RE: 15221 Cottonwood Court, Orland Park, Illinois
Visual Inspection of Roof Structure to Support Photovoltaic Solar Panels

SOLAR PV INSTALLATION PROJECT

**15221 Cottonwood Court, Orland
Park, IL 60467**

PLAN AND CONSTRUCTION SET 05/19/2017

ARRAY AND RACKING PLAN - SOUTHROOF

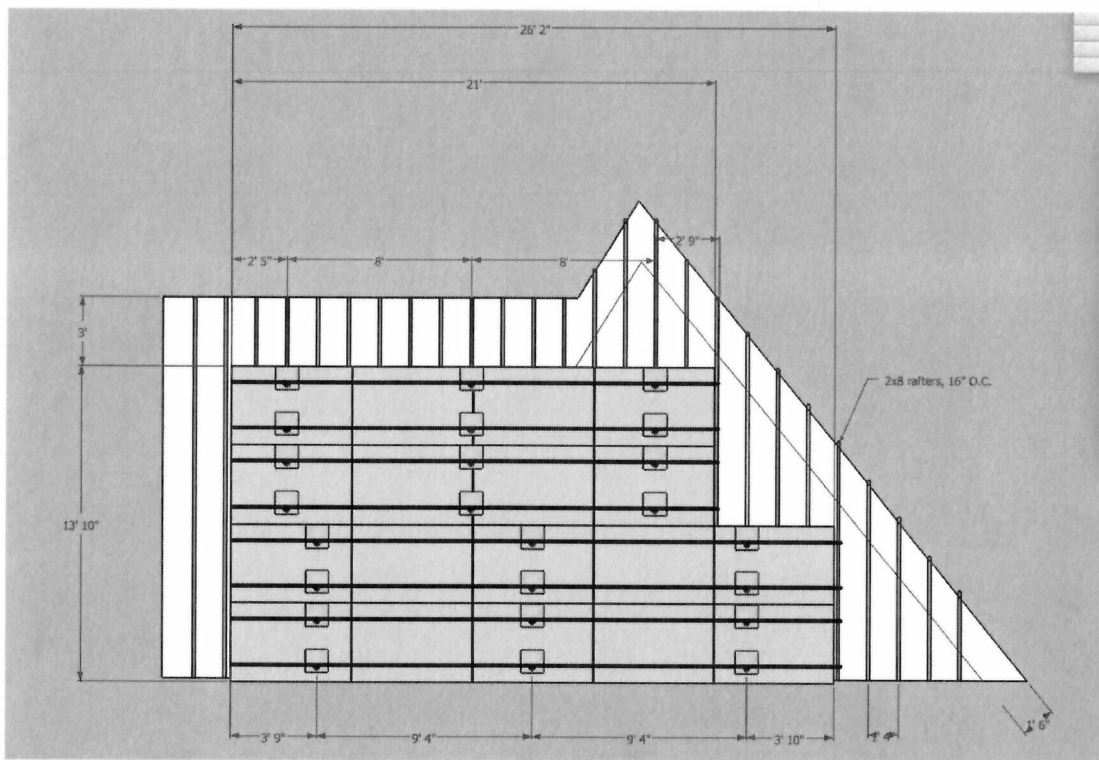
However, as there is a neighboring property in line with the solar panels you plan on installing on your south elevation, I was hoping you could work with your contractor to provide some type of assurance that "concentrated solar radiation or glare shall not be directed onto nearby properties". I ask this knowing the solar panels don't really reflect light, which would be contrary to their intended purpose of absorbing sunlight. But based on experience from a previous solar project, in which neighbors attended the Plan Commission meeting and wanted assurance that glare would not be an issue, I would like you to provide the Village with a letter or other documentation stating that your project will be in compliance with #7 above, which could be backed up by the professional experience of the contractor you are working with.

In our experience, none of the solar arrays being planned for Dr. Patel's property should pose a solar reflection or glare risk to any of the neighbors, including the south facing array and the neighbor directly to the south - so the installation will be in compliance with #7 above. For additional assurance, we have included a number of additional items below:

A scale plan drawing showing the expected direction of reflected sunlight on the Summer Solstice (the highest point in the year the sun will appear).

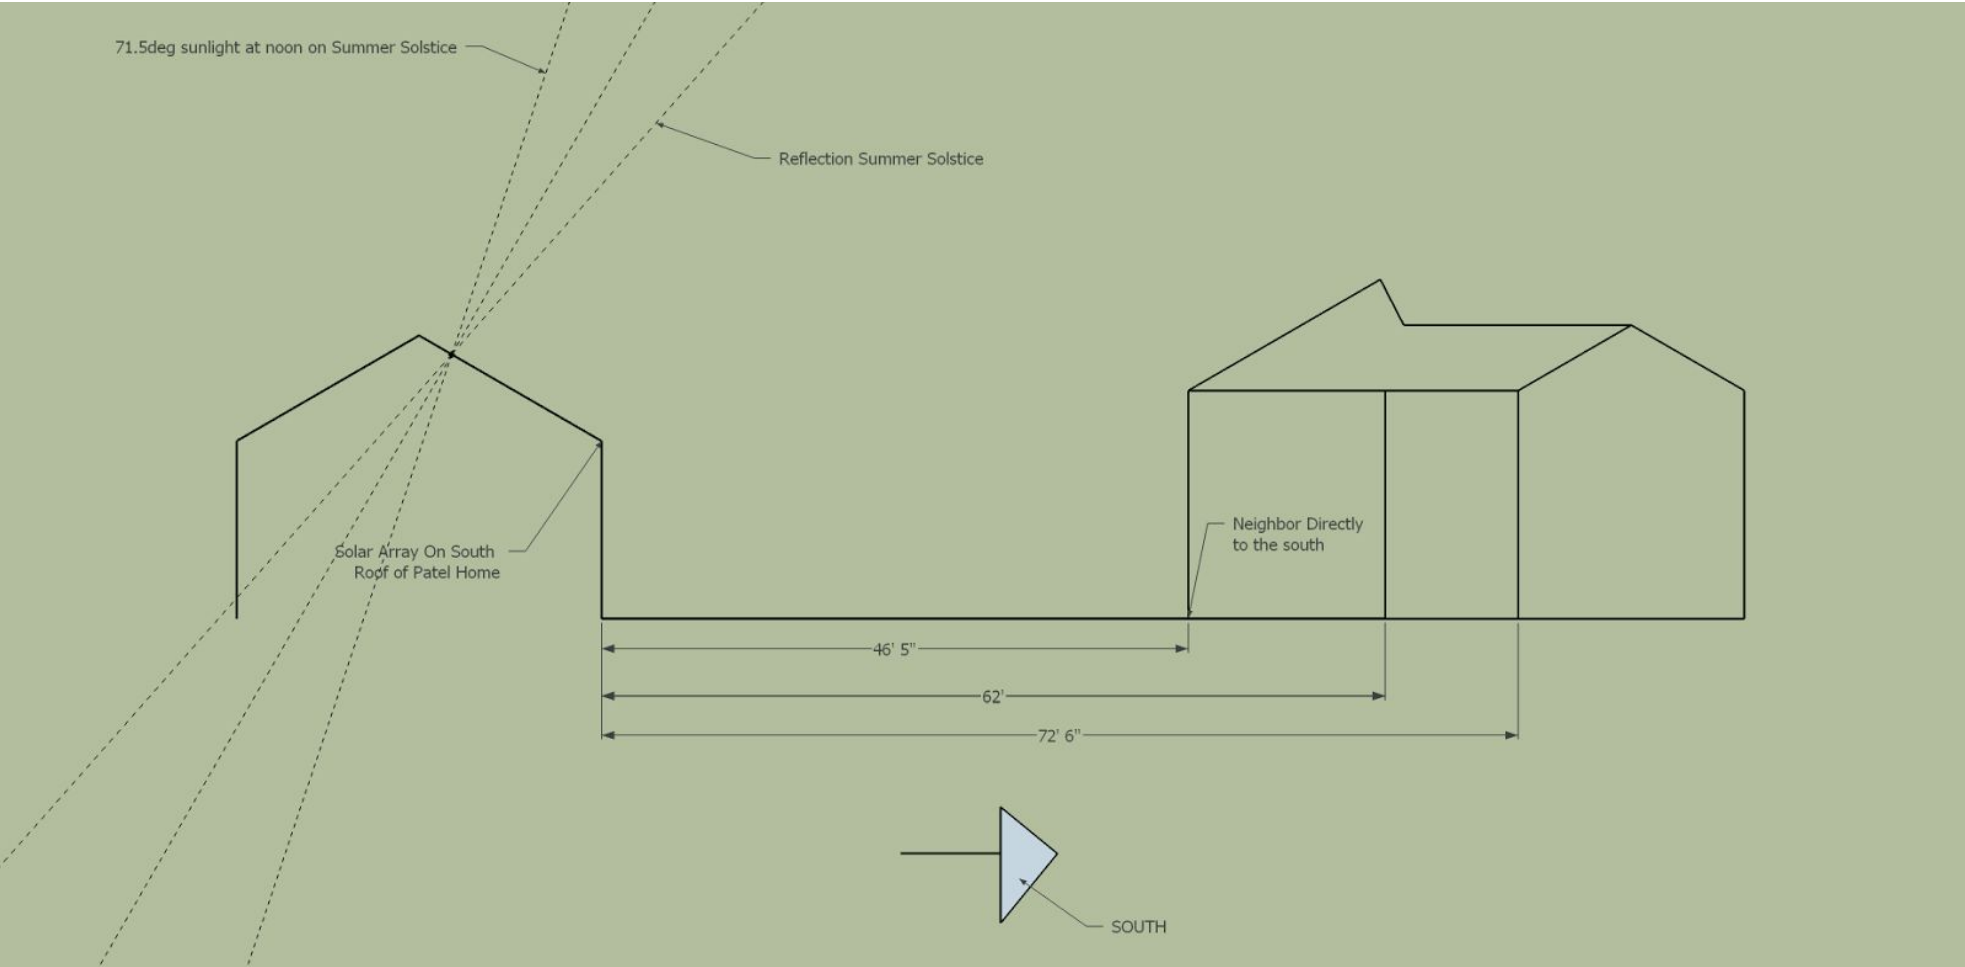
Thank you for your email of June 16 to Dr. Patel where you request assurance from the contractor that solar reflection from the south array should not pose a glare problem. Your note is here:

7) SES collector panels shall be placed such that concentrated solar radiation or glare shall not be directed onto nearby properties, roadways or public right-of-ways.

- A link to an industry article discuss solar reflection:
<http://solarprofessional.com/articles/design-installation/evaluating-glare-from-roof-mounted-pv-arrays#.WUgzcuvyuJC>
- A photo of the Patel home and the property to the south.
- A scale plan drawing showing the expected direction of reflected sunlight on the Summer Solstice (the highest point in the year the sun will appear).
- A scale plan drawing showing the expected direction of reflected sunlight on the Winter Solstice (the lowest point in the year the sun will appear).
